**From:** [smartforms@act.gov.au](mailto:smartforms@act.gov.au)  
**To:** [EPD, Customer Services](#)  
**Subject:** DA201835109 - REPRESENTATION - [REDACTED] [SEC=UNCLASSIFIED, DLM=Sensitive: Personal]  
**Date:** Tuesday, 22 January 2019 12:03:02 AM  
**Attachments:** [99125120190122001261.xml](#)  
[99125120190122001261.pdf](#)

Thank you for your representation regarding development application number: DA201835109

Figure 1 – Precinct Map

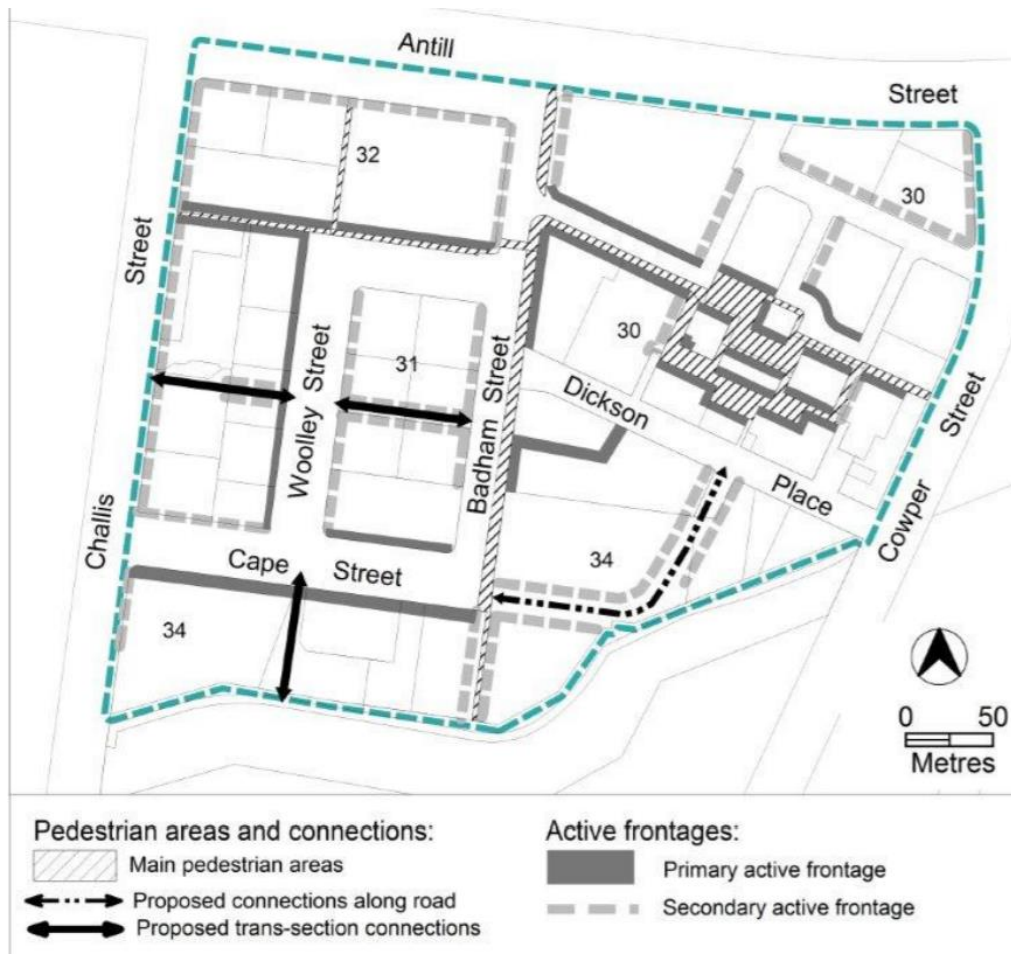
The Dickson Precinct Map and Code expressly requires the Activation of Street Frontages as per the diagram in Figure 1 below.

Implicit in this Rule in my opinion is a prioritisation of pedestrian movement over vehicular traffic on the street (Road A) that separates the Charter Hall/Woolworths site from the development site. This Rule is supported by the overarching objective to facilitate “*open and accessible pedestrian access throughout the centre*”. The achievement of this objective needs to be mindful of the focussing of pedestrian access towards Dickson Square and the community activities adjacent to the square.

Figure 2 – DA Plan Extract

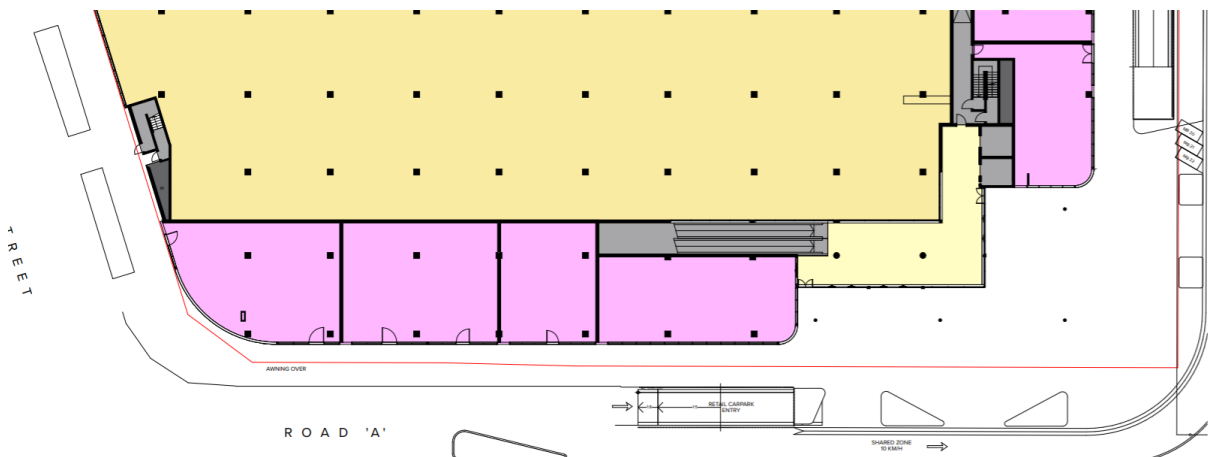
- The proposed plans show a row of speciality shops shaded pink fronting Road A as per the extract in Figure 2 below. It needs to be recognised that there is no means to service these shops other than via the front door off the street, precisely at the point where traffic for the overall development is being concentrated towards the entry to the basement access ramp. This in my opinion will lead to:

- Potential conflicts between service vehicles that will need to park on the street to access these shops;
  - Conflicts with pedestrians as servicing / loading / unloading activities will intersect planned pedestrian flow lines;

- The internalisation of these retail shops as they adopt measures to ensure shopper amenity is not unduly impacted by traffic noise;
  - The potential difficulty for these shops to be leased due to their poor amenity.

Figure 3 – Plan extracts previous DA Schemes

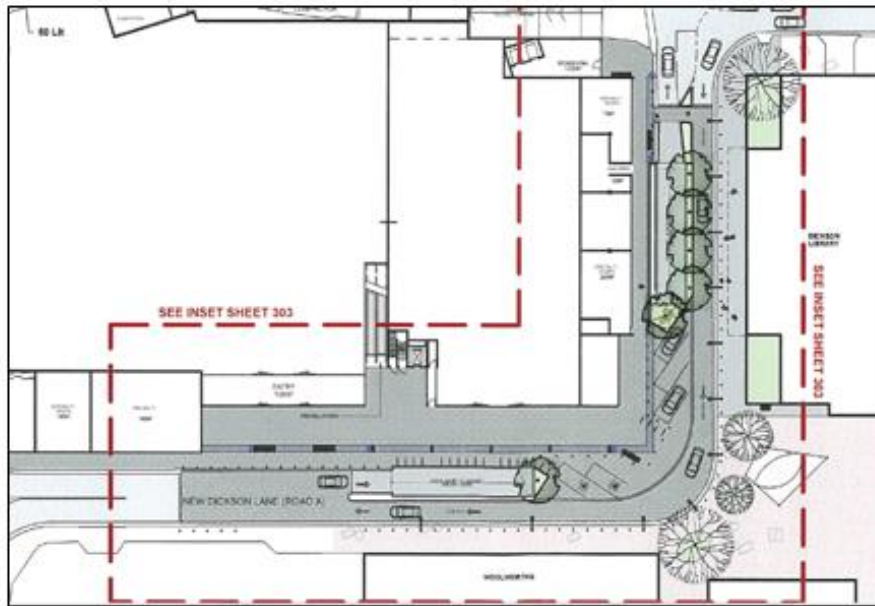
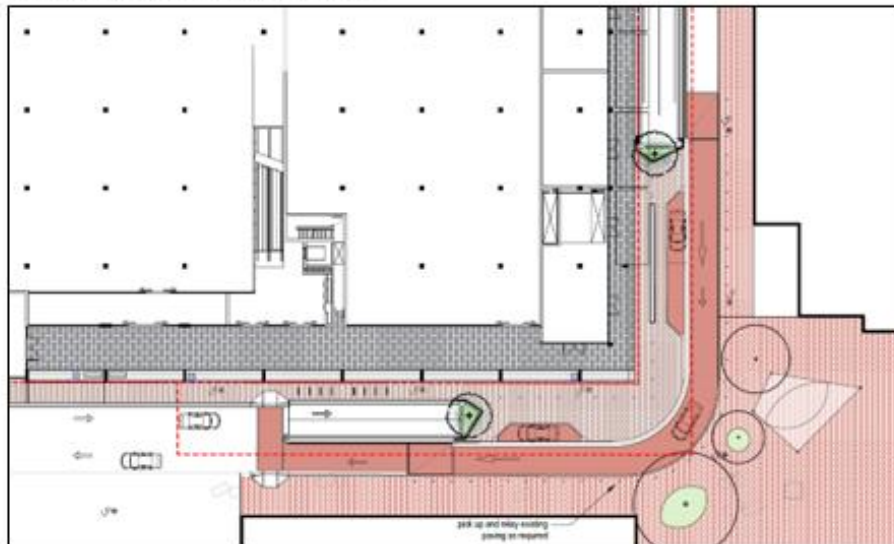
The following diagrams in Figure 3 below are extracts of previous schemes for the site. In our earlier submissions, consistent concerns were raised over the location of the travelators and the opportunity such could provide to better link private and public spaces. The diagrams overleaf show the earlier locations of the proposed travelator.

In our submission to the 2016 scheme, we recommended the realignment of the travelators to provide better connectivity into Dickson Plaza and surrounding land uses.

Figure 4 – Landscape Plan Extract: Current Scheme

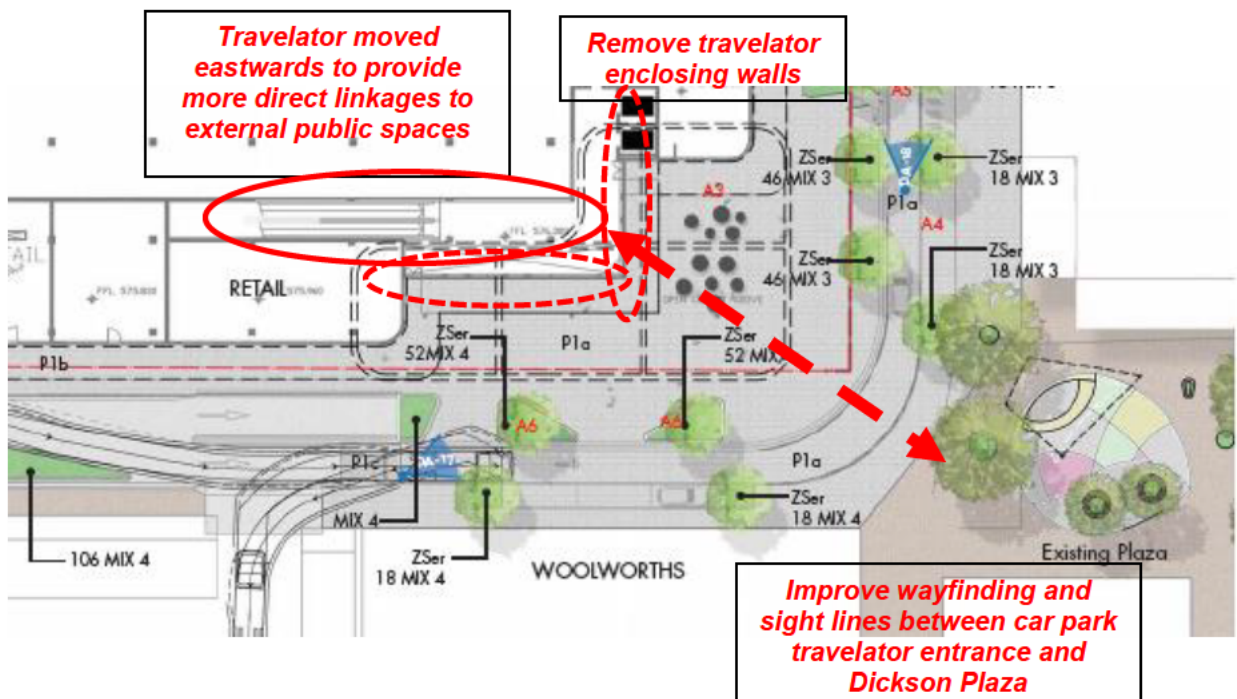
Based on my review of the landscape plan included with the DA documentation, there appears to be opportunity to reconfigure interface between the travelator and the proposed plaza space in the south-eastern corner of the site for the following reasons:

- At present the travelator effectively connects to a proposed supermarket lobby. This in my view has the effect of creating a perception that it is a private space for the exclusive use by the proposed development.
- The enclosed wall around the travelator continues to create a disconnection between a number of public spaces, including the publicly accessible car parking within the basement.

A seamless interface between public, semi-public and private spaces that enables pedestrians to readily identify and logically way-find throughout the entire precinct, particularly when public access extends across ground and below-ground levels must be a key design outcome. This outcome is reflected in the marked-up extract of the latest Landscape Plan in Figure 4 below.
